GWF Henrietta Peaker Power Plant Project (01-AFC-18)

Amendment 2

California Energy Commission

March 2013

FIGURE 2-1a
Water Balance, Peak
GWF Henrietta Peaker Plant

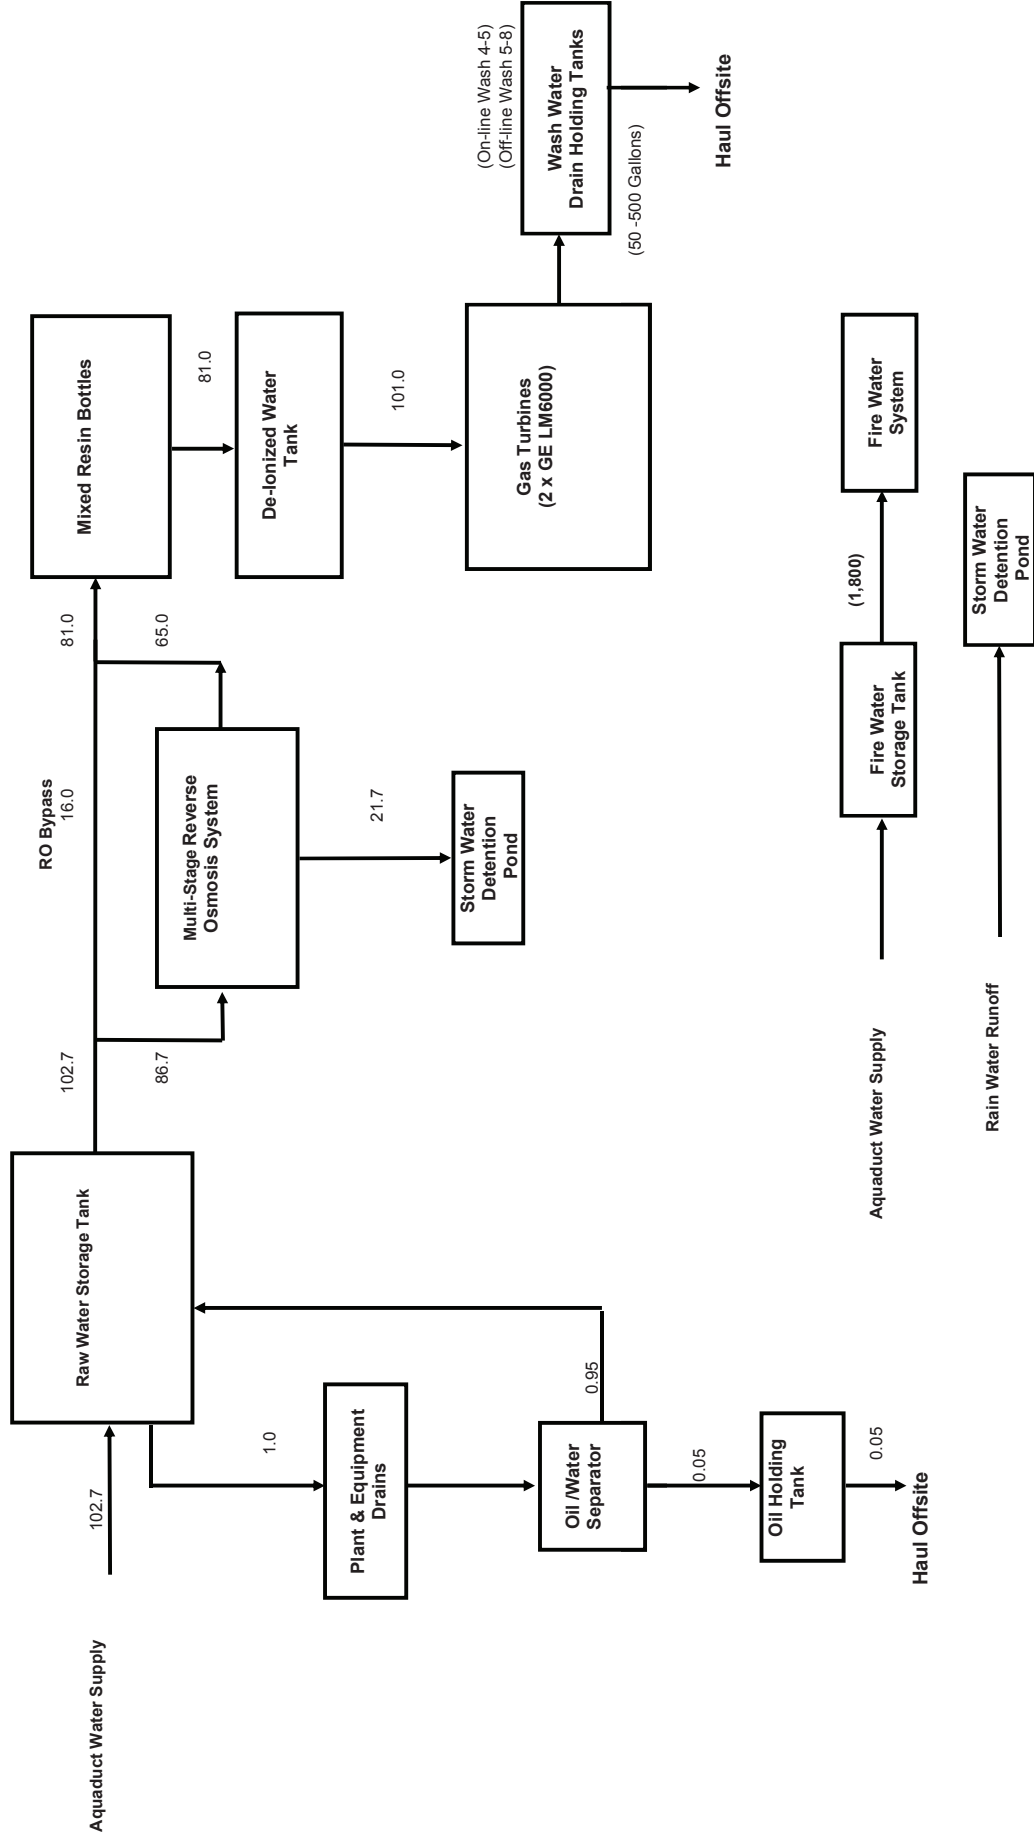
As noted above, HPP uses a contract-based deionization system and GWF seeks to install a permanent single pass RO treatment system as the primary raw water deionization treatment process. The existing portable water treatment system would be used to supplement or “polish” the RO effluent prior to use in the combustion turbines and the primary treatment system when the RO system is in “by-pass” or out of service.

GWF proposes to discharge the RO reject water to the facility’s storm water basin. Figures 2-1a and 2-1b present water balances for peak and annual average water use, respectively. The RO treatment system would require the use of approximately 400 gallons of an anti-scalant for water treatment. This material would be contained in a single tote located near the existing water treatment area. Appendix A is a copy of the Material Safety Data Sheet for the anti-scalant.
